NCFMP and NCDOT MOA Project Review

Project TIP:	R-2527	Stream Name:	Clark's Creek
Sch Let Date:	11/29/2019	Route Number:	NC 24/27
CLOMR Case Number:	N/A	Road Name on Panel:	NC 24/27
Municipality:	N/A	Effective FIS Date:	01/02/2008 (6/16/2009)
County:	Montgomery	Panel Number:	6586
CID Number:	370336	Panel Effective Date:	9/3/2008
Project Engineer:	Craig Lee, PE	Bounding Stations:	600/590
Project Reviewer:	Matthew Dudley, PE

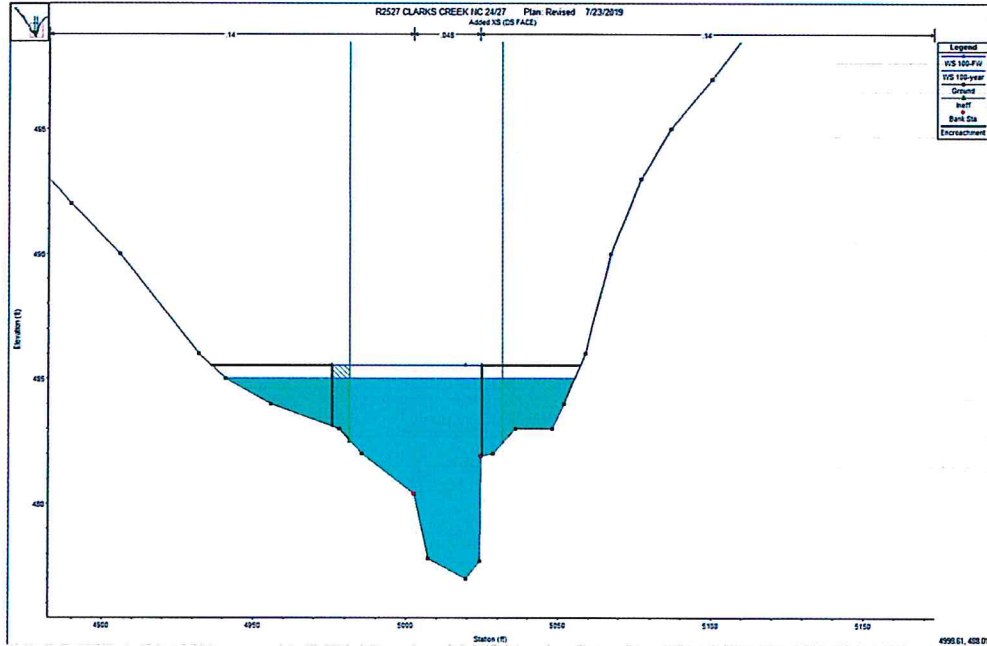
1. Current modeling guidance indicates to use 0.98 max submergence, please verify the maximum submergence value in the Corrected Effective and Revised plans within the noted project area and revise as appropriate.
 - The max submergence value under Deck/Roadway has been updated to 0.98 in the Corrected Effective and Revised model. These models were re-run accordingly.
 - Verified, no further action is needed.
2. For the Revised plan, please verify the encroachment station placement at RS 59463. The left encroachment station is within an ineffective area. Encroachments must be placed in areas of

- The left encroachment station has been moved to the left ineffective station at RS 59463. Surcharges were reviewed as well and they still fall within the allowable ranges.
- Verified, no further action is needed.

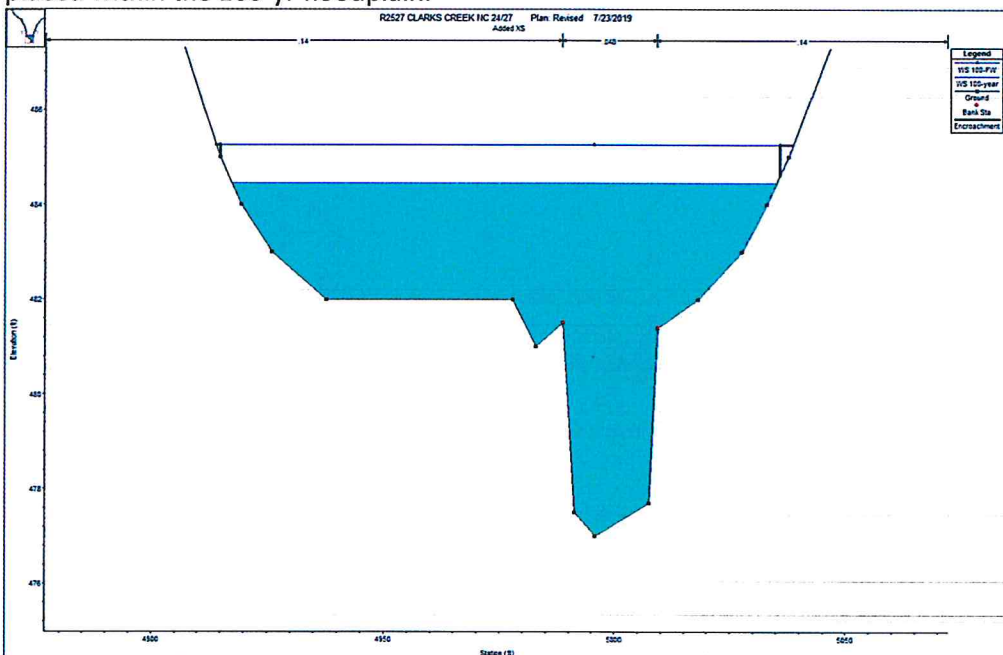
3. Please verify encroachment placement at RS 59372 for the Revised plan. The left and right encroachment stations are placed outside of the 100-year floodplain. Encroachments must be placed within the 100-yr floodplain.

4. Please verify the roadway width for the structure at RS 59569 in the Revised plan. The HEC-RAS MOA model shows the roadway width to be 124.8 ft; however, the BSR reports a recommended roadway width of 120 ft.

- The encroachment stations were moved to be within the 100-yr floodplain at RS 59372. Surcharges were reviewed as well and they still fall within the allowable values.
- Verified, no further action is needed.

- The road width has been corrected to 120 ft to be consistent with the CSR.
 - Verified, no further action is needed.
5. NCFMP practice is to assume culverts flow unobstructed. The channel ground points should contain the culvert barrel and allow flow without any blockages. For the structure at RS 59569 in the Corrected Effective plan, please consider revising the ground points as needed to contain the culvert.
- The channel ground points were updated in the Corrected Effective model to show no obstruction in the culvert barrel.
 - Verified, no further action is needed.
